tyco SimplexGrinnell

SHEET TITLE: FIRE ALARM SYSTEM FIRST FLR PLAN PART B

SHEET NUMBER: FA-102

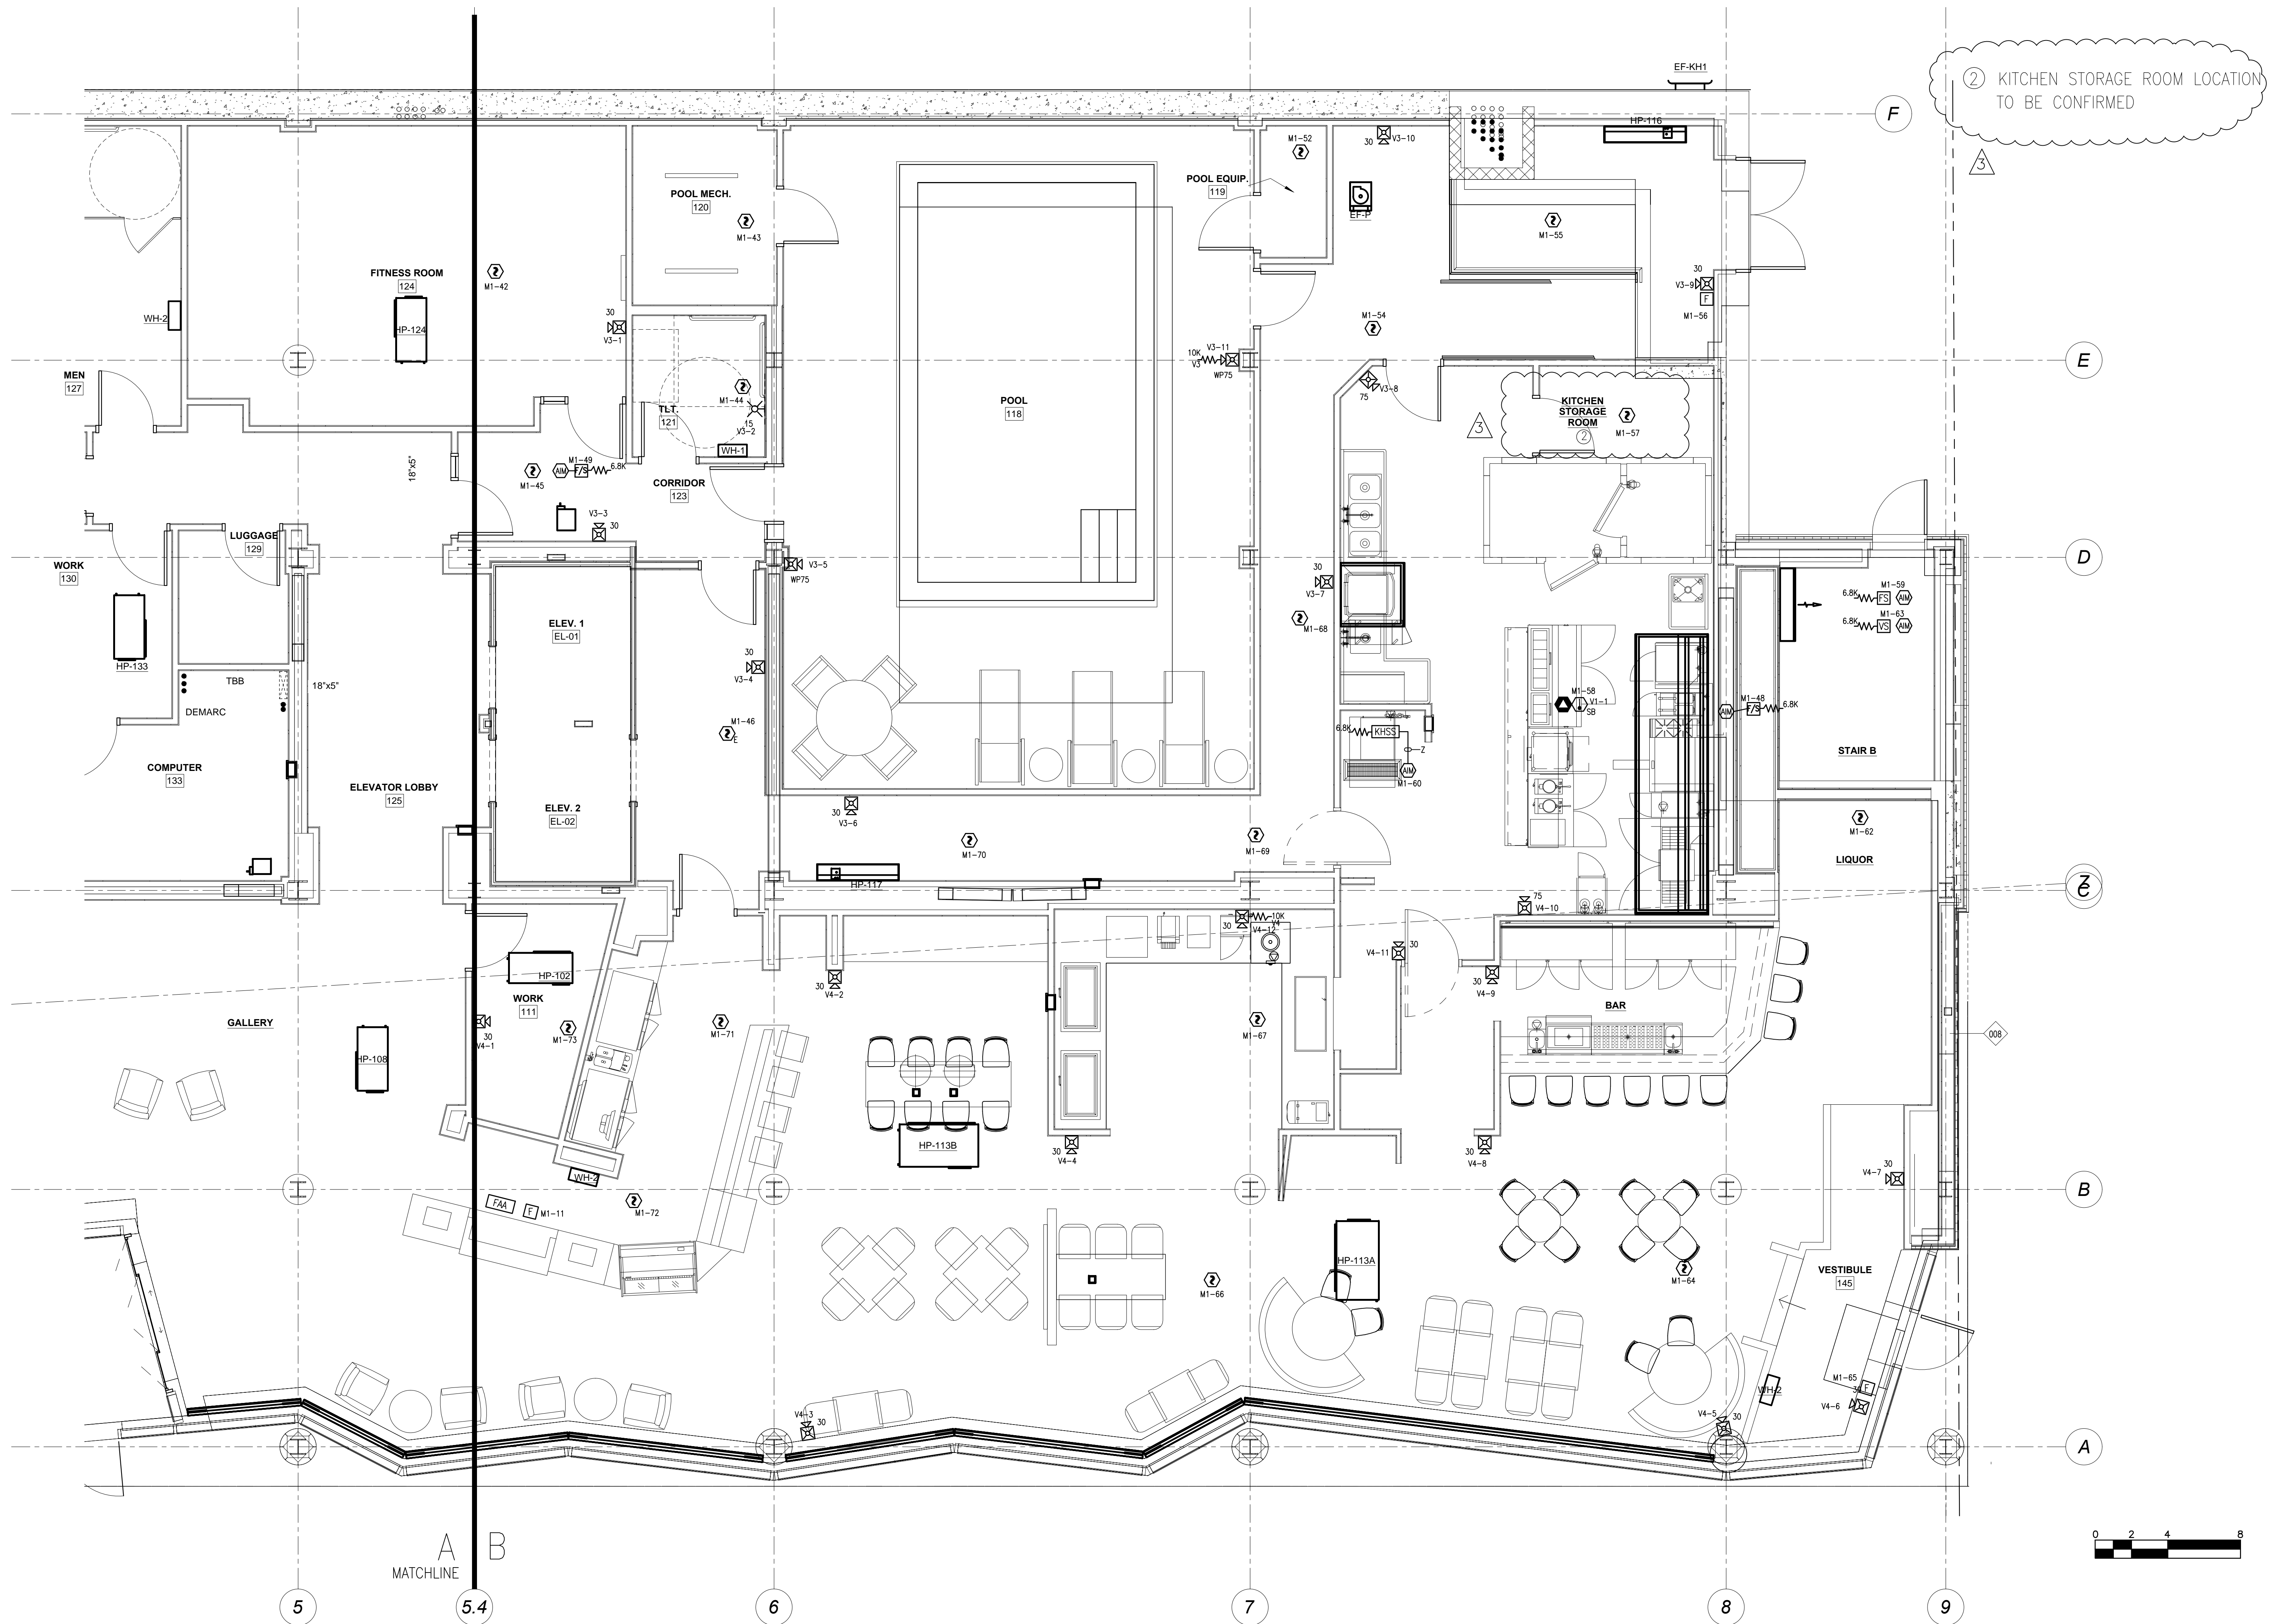
2 KITCHEN STORAGE ROOM LOCATION TO BE CONFIRMED
